Subject: March 30-31, 2022 SPCC Inspection Report for R+L Carriers, Inc. Wilmington Service Center (WIL Terminal); Facility ID: R5-OH-00474

SPCC FIELD INSPECTION AND PLAN REVIEW CHECKLIST

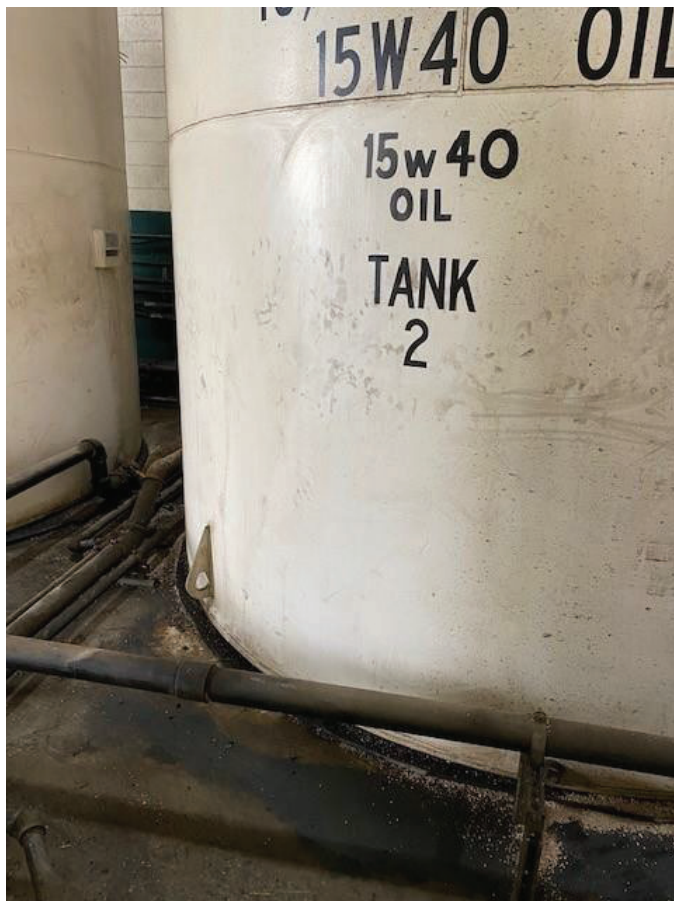
Description: Maintenance Building Oil Storage Room secondary containment. Note staining and oil-dri material around bottom tank.

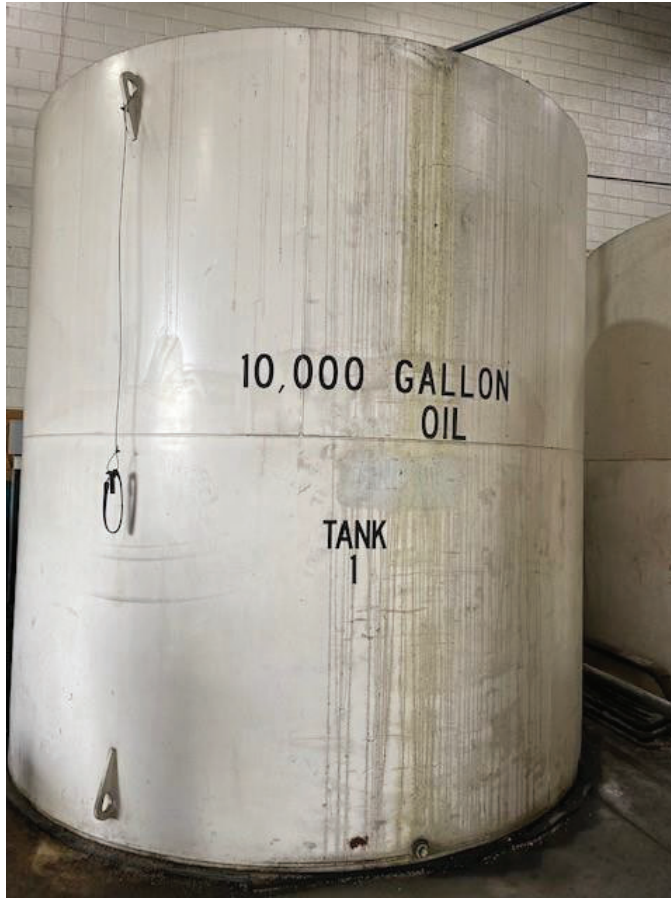
Description: Maintenance Building Oil Storage Room Tank # 14 (per SPCC Plan). Note staining and oil-dri material in secondary containment; staining on top of piping.

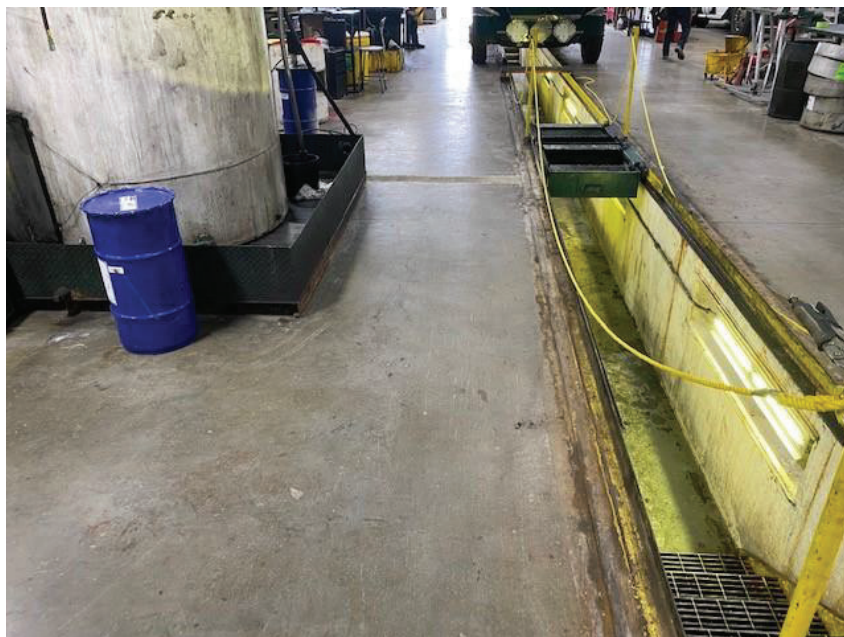
Description: Photo has been altered from original in order to remove visible employees. Maintenance Building Tank # 2 with secondary containment. Note staining on tank.
